**Project:** GOLDEN GATE BEAUTIFICATION, M.S.T.U.  
**Project Manager:** Leslie Hayes, MSTU Project Manager, C.C.P.S.D. – P.T.N.E. Dept.  
**Consultant:** McGee & Associates  
**Contractor:** Hannula Landscaping & Irrigation Inc.  
**Report Period:** FY 14-15, September 2015

**Location:** Collier Blvd. Part A & B  
**Consultant's Representative:** Michael A. McGee, rla, isa  
**Contractor's Representative:** Dale Hannula  
**Report No.:** Twelve – FY 14-15

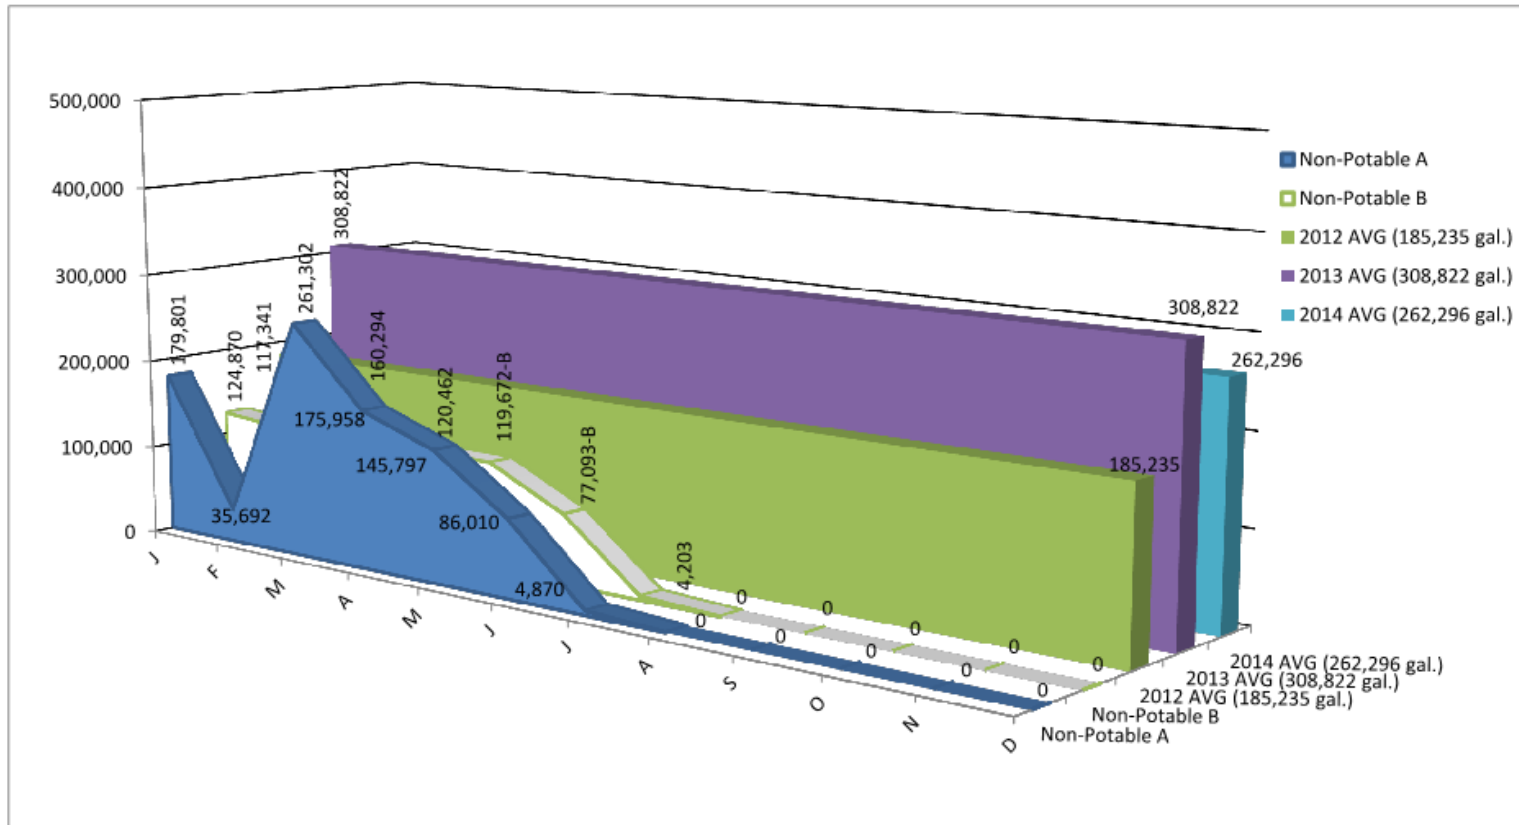
<b>Median #8</b>		X	16	Juniper bed on south end of median contains dead plants and brown foliage. Remove both and provide count for replacements.	
		X	20	Plant replacements are needed in multiple areas.	Hannula 12/20/13: An estimate cannot be submitted without knowing the recommended species for replacement and a plant count. M&A 1-15-14: Please call our office to schedule an on-site meeting to review median.
<b>Median #9</b>		X	26	Review Juniper on north and south end for replacements due to auto damaged.	Hannula 12/20/13: Plant count is needed by next drive through
<b>Median #10</b>		X	21	Review south end Juniper bed for replacements.	
		X	20	Turf areas need to be reviewed for dead areas that need to be replaced.	Provide proposal with square footages per median.
